## **COSGROVE SUBDIVISION**

APPLICATION NUMBER 14 DATE June 6, 2013  
 APPLICANT Cosgrove Subdivision  
 REQUEST Subdivision

# DETAIL SITE PLAN

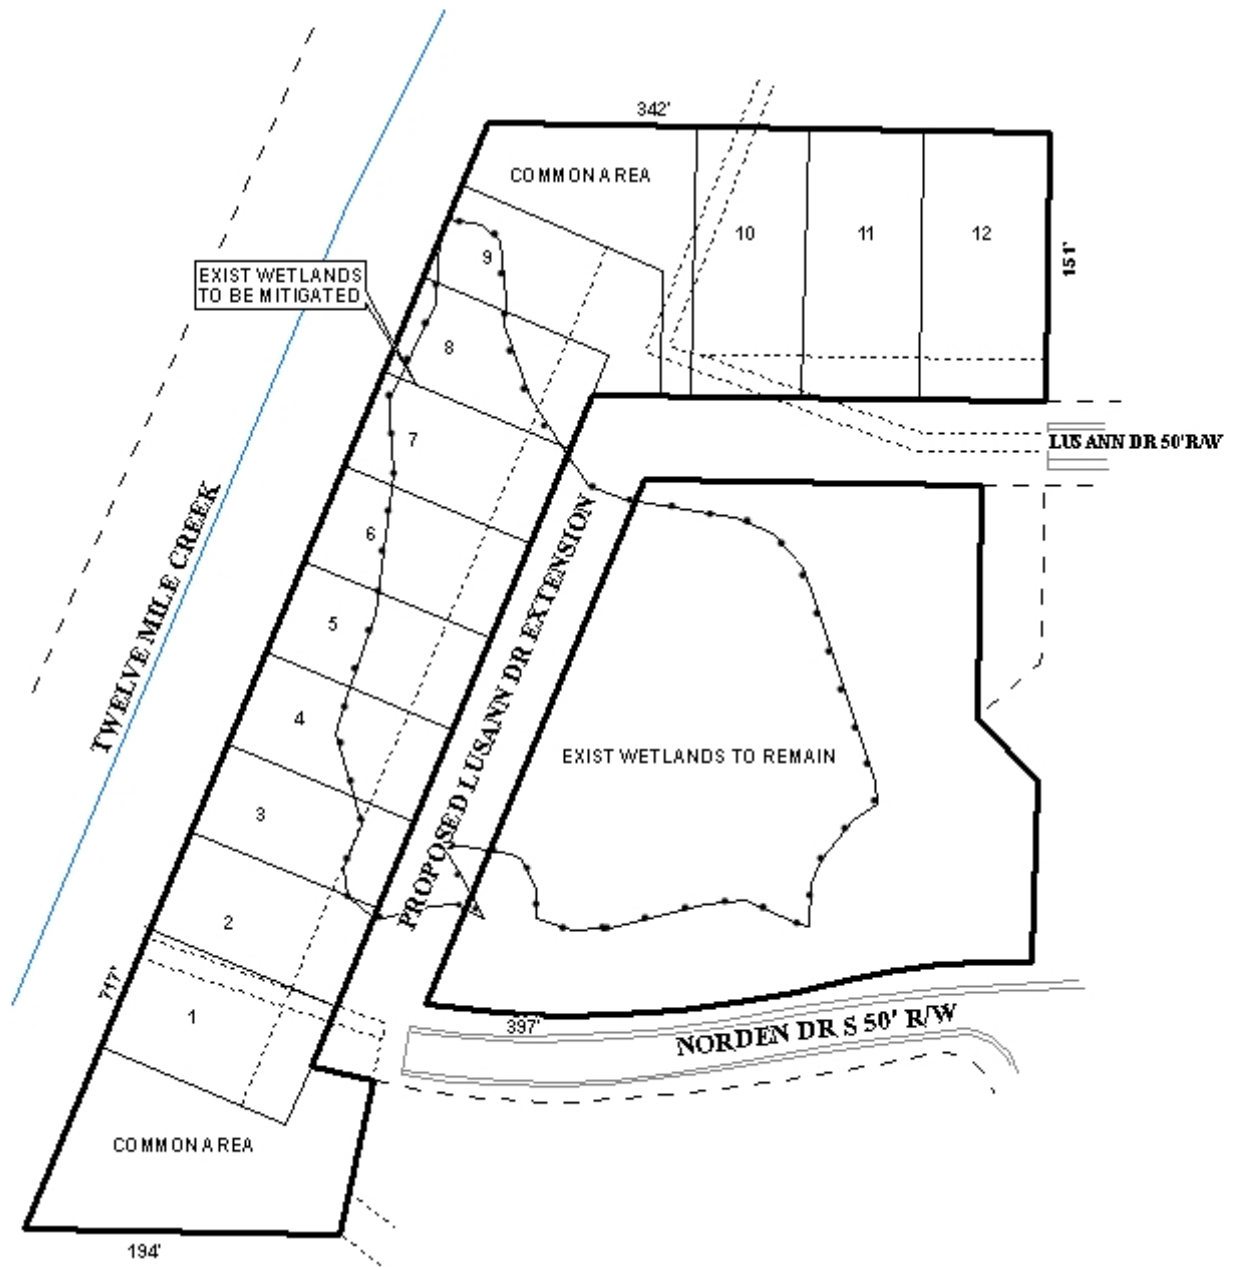
It should be pointed out that Section V.B.12. of the Subdivision Regulations requires that the minimum radius of curvature of streets on the centerline shall be 100 feet for a minor street. As this is a new minor street, the plat should be revised to comply with these requirements.

The applicant is proposing 12 lots. Each lot will meet the minimum area requirement for properties served by water and sewer systems. All lots, with the exception of Lots 1, 8 and 9, will meet the minimum frontage width requirement of 60-feet. Proposed Lots 1, 8 and 9 are located at curves of the new road, thus the lots will only have 35 to 40 feet of frontage, however, the lots quickly widen to 60-feet in width. As proposed, a waiver of Section V.D.2. regarding minimum lot width will be required.

Access management is a concern due to the fact that each lot will have limited frontage. Each lot should be limited one curb-cut each, with the size, design and location to be approved by Traffic Engineering and conform to AASHTO standards. Common areas are also proposed, and in order to facilitate access for maintenance, each common area should be limited one curb-cut each, with the size, design and location to be approved by Traffic Engineering and conform with AASHTO standards.

Multiple drainage and sanitary sewer easements exist on the site. A note should be placed on the final plat, if approved, stating that no structure may be built within any easements.

As common areas and detention basin common areas are proposed for the subdivision, a note should be placed on the Final Plat, if approved, stating that maintenance of the detention basin common areas, and any other common areas, are the responsibility of the subdivision's property owners.

A sidewalk waiver application was not submitted with the Subdivision application, thus sidewalks will be required within the development.

- 1) Revision of the plat to reflect compliance with Section V.B.12. of the Subdivision Regulations regarding the minimum radius of curvature of minor streets;

- 2) All new road construction must comply with Engineering Department requirements;
- 3) Placement of a note on the final plat stating that each lot and common area is limited to one (1) curb-cut each, with the size, design and location of all curb-cuts to be approved by Traffic Engineering and conform to AASHTO standards;

- 4) Placement of a note on the final plat stating that no structure may be built within any easements;
- 5) Depiction of the 25-foot minimum building setback line from all street frontages as required by Section V.D.9. of the Subdivision Regulations;

- 6) The labeling of each lot with its size in square feet, or placement of a table on the plat with the same information;
- 7) Labeling of all common areas, including detention common areas, and placement of a note on the final plat stating that the maintenance of the common areas is the responsibility of the property owners;

- 8) Provision of sidewalks along all new streets within the development;
- 9) compliance with Engineering comments (*The following comments should be addressed prior to review, acceptance and signature by the City Engineer: 1. Provide all of the required information on the Final Plat (i.e. signature blocks, signatures, certification statements, legal description, required notes) including the Professional Land Surveyor seal and signature. 2. Provide a signature block and signature from the Planning Commission, Owner(s) (notarized), and the Traffic Engineering Department. 3. Provide a signature block for the City Engineer and the County Engineer. 4. A Land Disturbance Permit will be required for the roadway improvements to the proposed ROW. These improvements will require storm water detention in accordance with the Storm Water Management and Flood Control Ordinance (Mobile City Code, Chapter 17, Ordinance #65-007 & #65-045). 5. Any work performed in the existing ROW (right-of-way) such as driveways, sidewalks, utility connections, grading, drainage, irrigation, or landscaping will require a ROW permit from the City of Mobile Engineering Department (208-6070) and must comply with the City of Mobile Right-of-Way Construction and Administration Ordinance (Mobile City Code, Chapter 57, Article VIII). 6. All roadway, utility, and storm drainage improvements associated with the proposed ROW must be complete, tested, and accepted by the Engineer-of-Record. 7. Must comply with all Engineering Department Policy Letters: (i.) 8-4-2004 Policy Letter (Video inspection of new Storm Sewer System Piping); and (ii.) 3-18-2004 Policy Letter (Additional subdivision street requirements); 8. The City Engineering Department must provide Final Inspection*)
